TITLE: Notification that – ISO/IEC 14443-3:2010/FDAM4 - Identification cards - Contactless integrated circuit(s) cards - Proximity cards - Part 3: Initialization and anticollision - AMENDMENT 4: Electromagnetic disturbance handling and single size UID – has been posted to the ISO server for FDAM ballot

ISO/IEC 14443-3:2010/FDAM 4:2010(E)

AMENDMENT 4: Electromagnetic disturbance handling and single size UID

Figure 1 — Frame delay time PCD to PICC

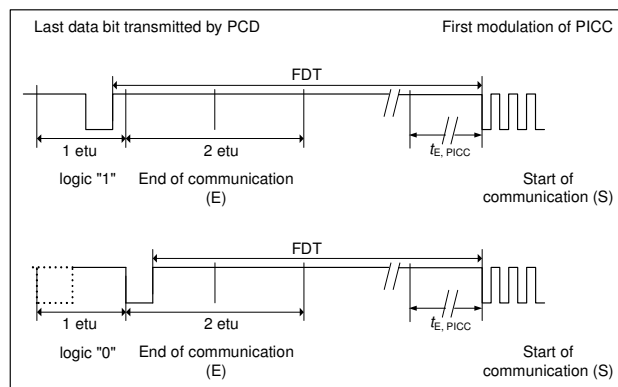
Page 7, 6.2.1.1

Replace Figure 1 with the following figure and add the note after Figure 1:

"NOTE $t_{E,PICC}$ is specified in clause 8."

Figure 17 — Timing before the PICC SOF

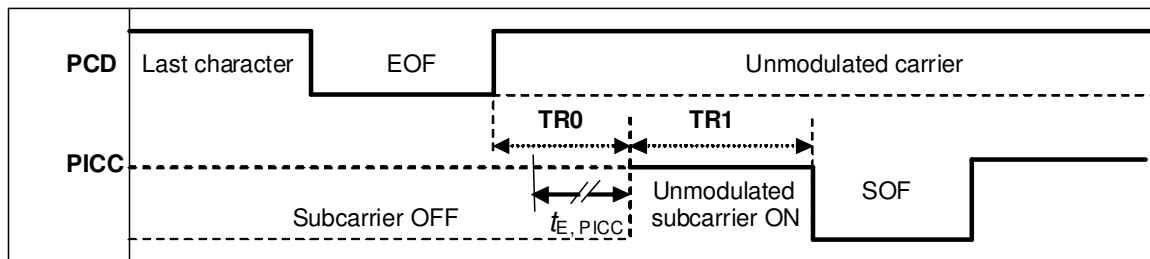
Page 28. 7.1.6

Replace Figure 17 with the following figure and add the note after Figure 17:

"NOTE $t_{E,PICC}$ is specified in clause 8."

Figure 33 — Low EMD time

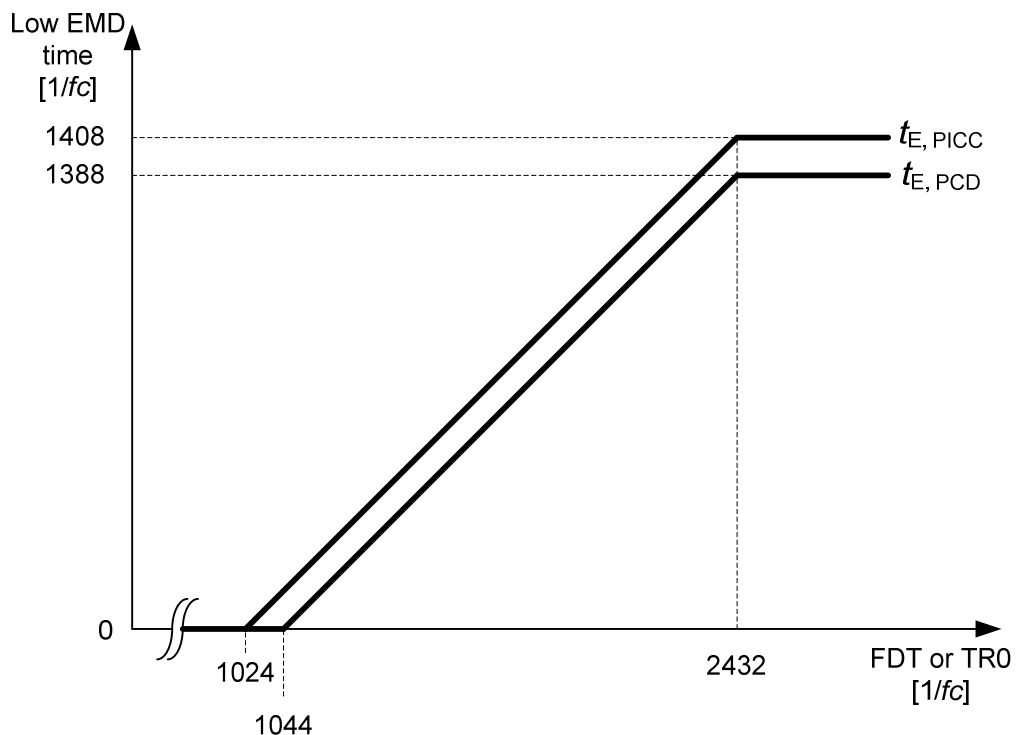
The low EMD time for PCD and PICC are illustrated in Figure 33.

The low EMD time $t_{E,PICC}$ is the time period before the start of PICC data transmission, when the PICC shall not produce an EMD level higher than the EMD limit as defined in ISO/IEC 14443-2/Amd.3.

This low EMD time $t_{E,PICC}$ has a value of $F - 1024/fc$ with a maximum value of $1408/fc$ where F equals FDT for Type A and TR0 for Type B. The value is $0/fc$ for $TR0 \leq 1024/fc$.

The low EMD time $t_{E,PCD}$ is the time period to allow the PCD to recover from electromagnetic disturbances.

The PCD shall be ready to process a PICC frame no later than $t_{E,PCD}$ after the last time the EMD level was above the EMD limit as defined in ISO/IEC 14443-2/Amd.3.

This low EMD time $t_{E,PCD}$ has a value of $F - 1044/fc$ with a maximum value of $1388/fc$ where F equals FDT for Type A and TR0 for Type B. The value is $0/fc$ for $TR0 \leq 1044/fc$.
